Revised 15 April 2005
File No. 28590-008

Subject: Final Engineering Report for Tarrytown Former MGP Site
Tarrytown, New York
Site No. C360069
Brownfield Cleanup Index No. W3-1007-04-06

Subject: Remedial Action Report – Response to Comments
Tarrytown Former MGP Site
Tarrytown, New York
Site No. C360069
Brownfield Cleanup Index No. W3-1007-04-06

FIGURE 4.11

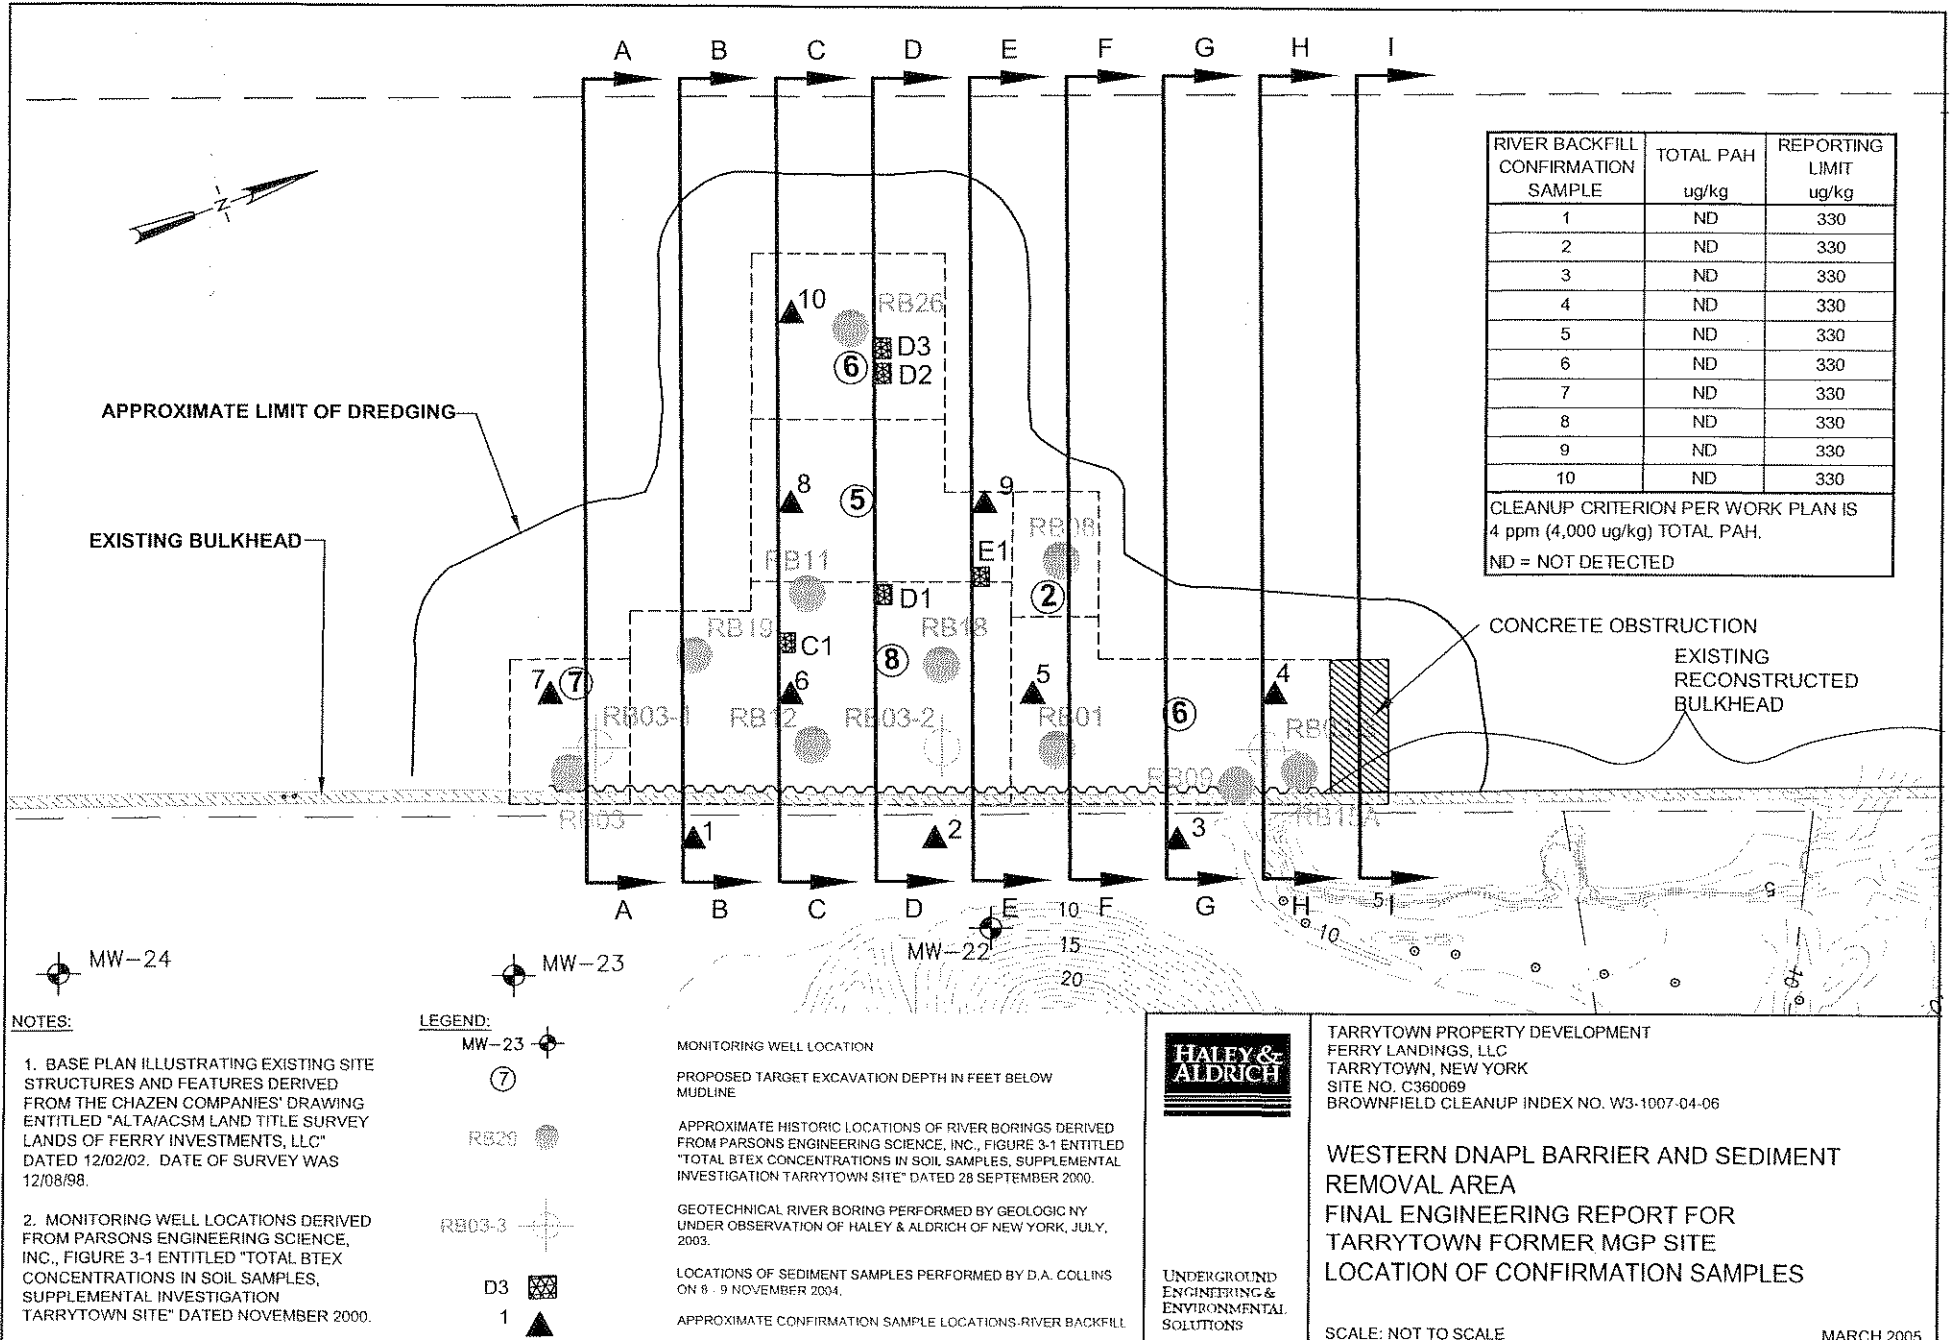
16. *Figure 4.11, please provide the results of post construction testing for total PAHs and BTEX superimposed on the sample location map.*

Response: The approved Work plan called for testing of total PAHs only, not BTEX. Results of the backfill sampling laboratory testing for total PAHS were added to Figure 4.11.
